WEBSTER U -
INTERDISCIPLINARY
SCIENCE BLDG
WEBSTER GROVES, MISSOURI

DRAWING TYPE: SHOP DRAWINGS
DRAWN BY: MMC
STANDARDS REVIEW: RJB
TECHNICAL REVIEW: RJB & RLB

SUBMITTAL IDENTIFICATION SHEET

RE: Linear Wood Ceiling Shop Drawings

Z-001

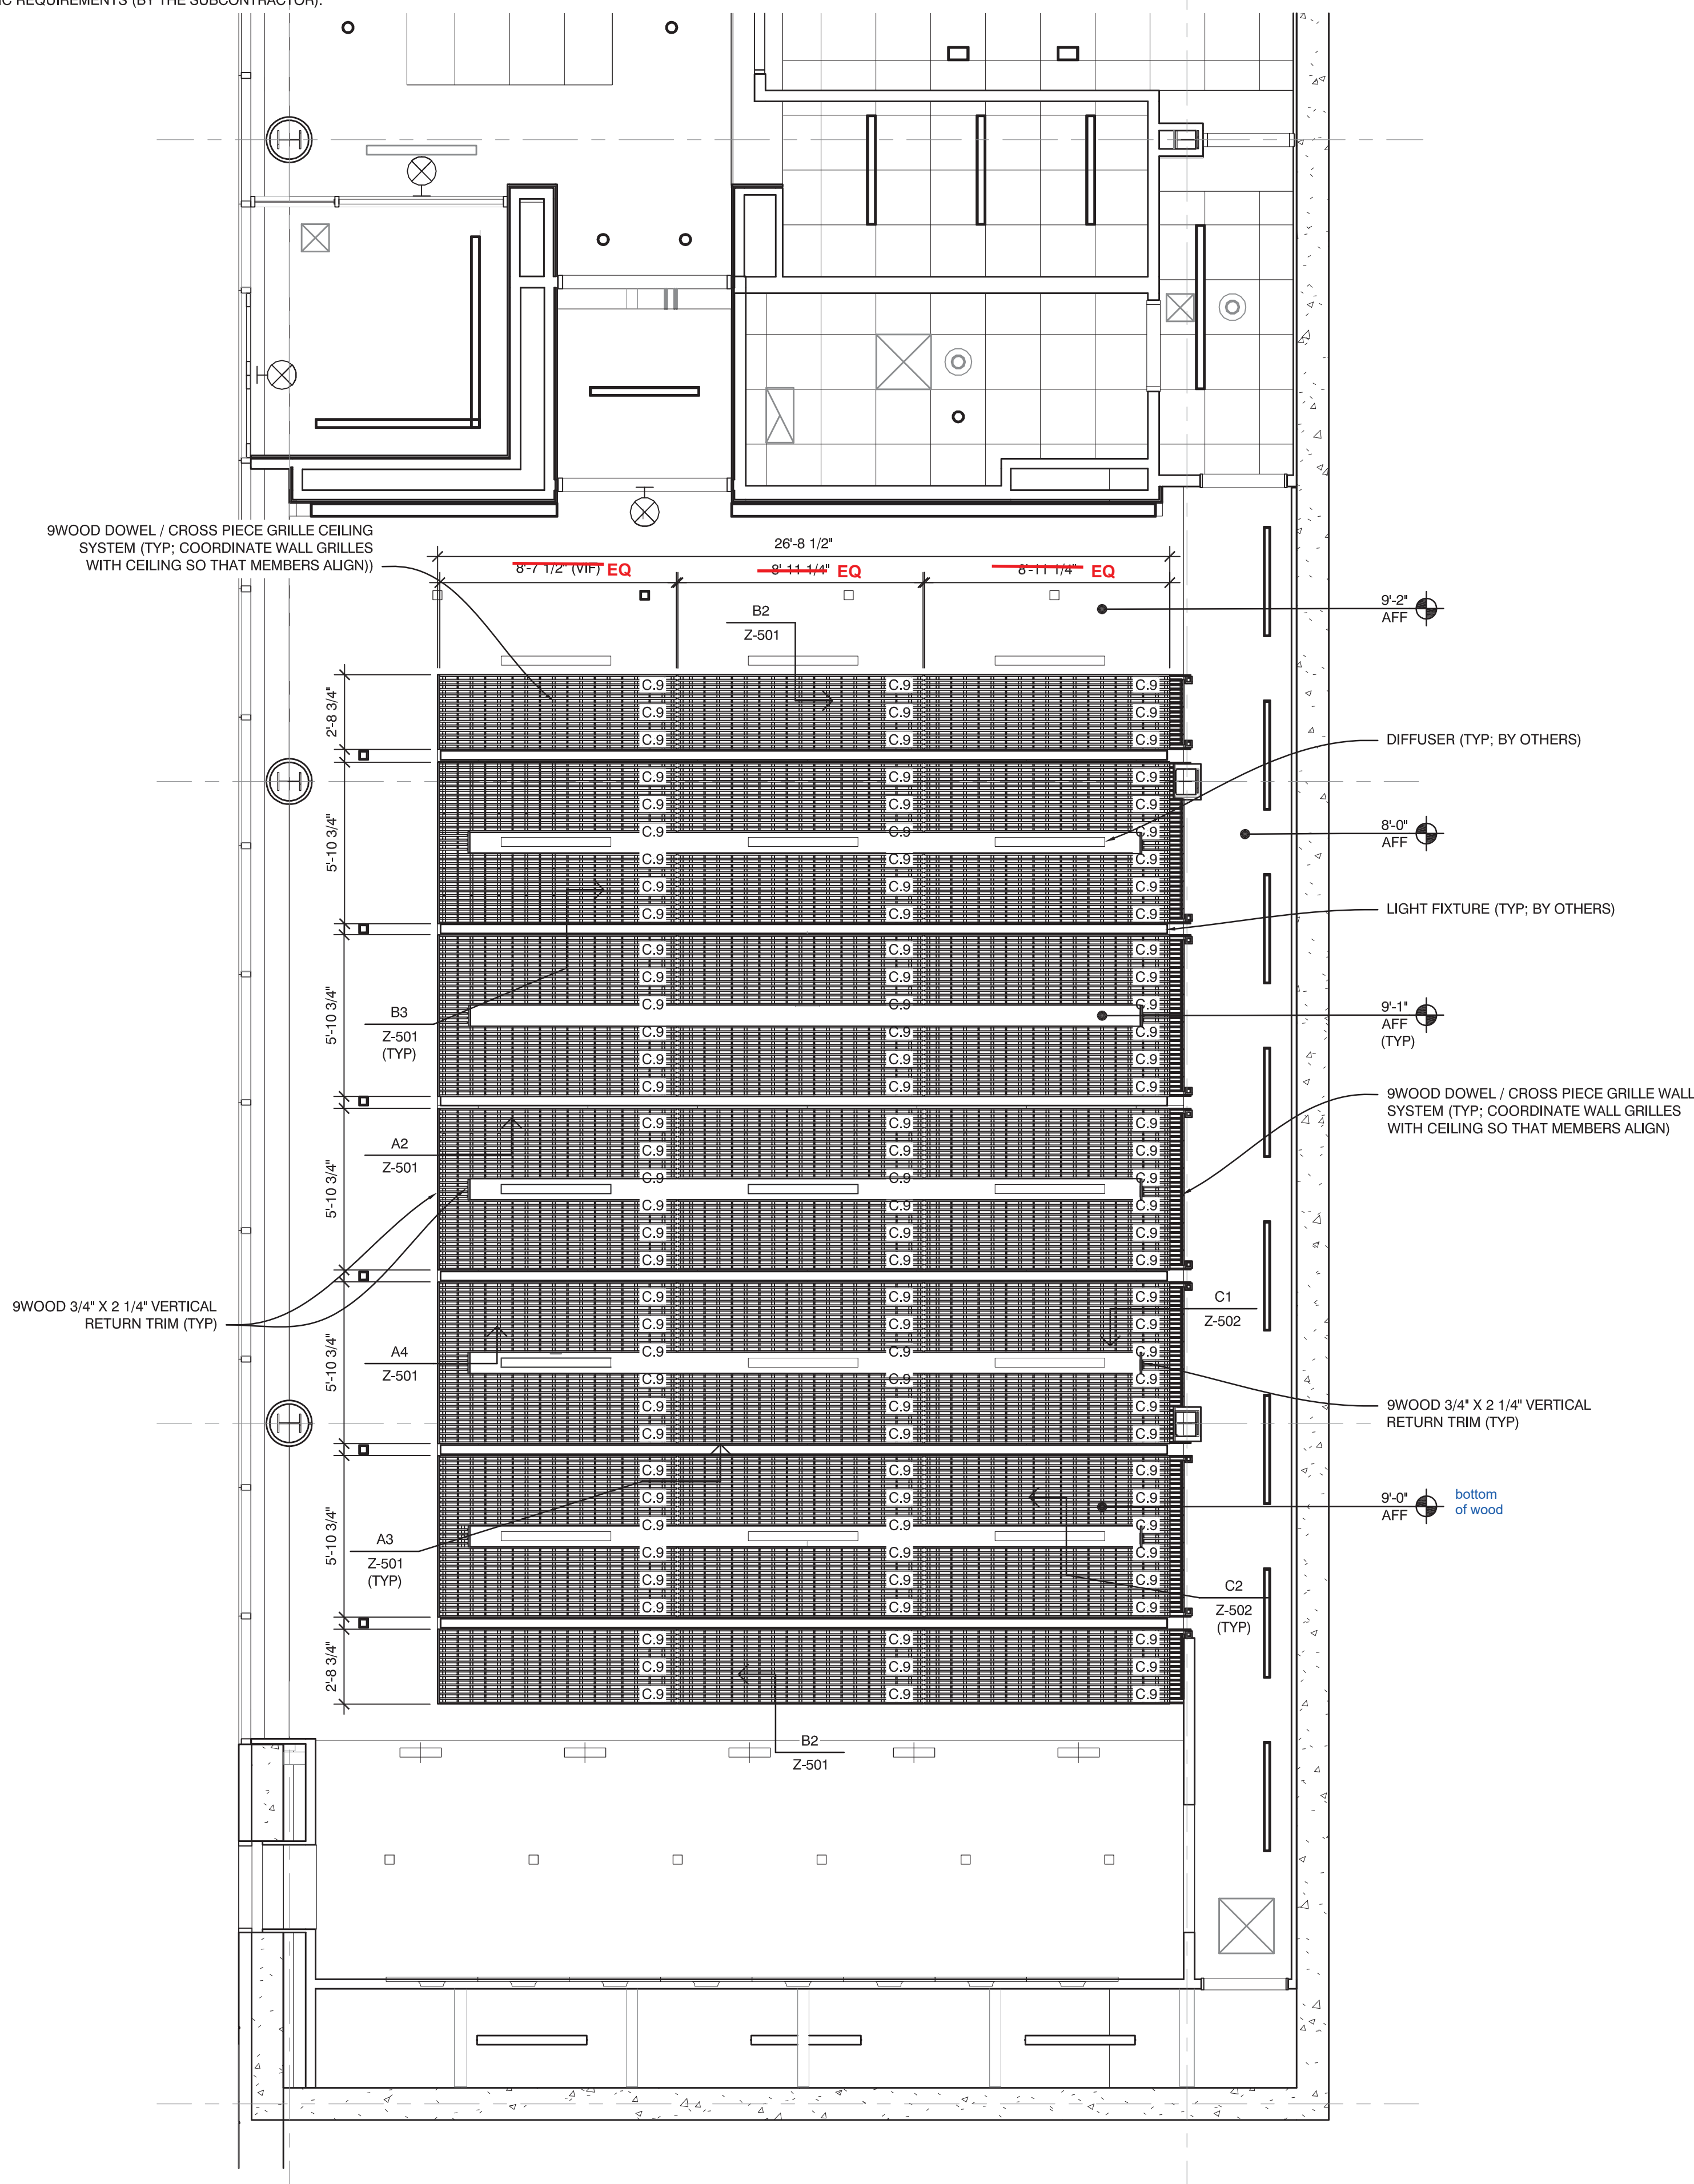
- FINISH:** THE FINISH OF THE WOOD CEILING GRILLES CONSISTS OF A SEALER COAT AND A TOP COAT OF 9WOOD STANDARD CLEAR FINISH WITH A SATIN SHEEN.
 - CRATING:** STANDARD CRATE SIZES ARE NOMINALLY 4' WIDE X 9' LONG X 4' TALL AND WEIGH APPROXIMATELY 2500 LBS. A FORK LIFT AND / OR LOADING DOCK IS REQUIRED FOR REMOVAL FROM THE TRUCK AT THE JOB SITE. Contractor responsible for unloading.

- FINISH:** FIELD CUT EDGES ~~MAY~~ REQUIRE A CLEAR SATIN STANDARD FINISH BE APPLIED TO THE RAW SURFACE (PERFORMED IN THE FIELD BY THE SUBCONTRACTOR). Contractor to provide samples
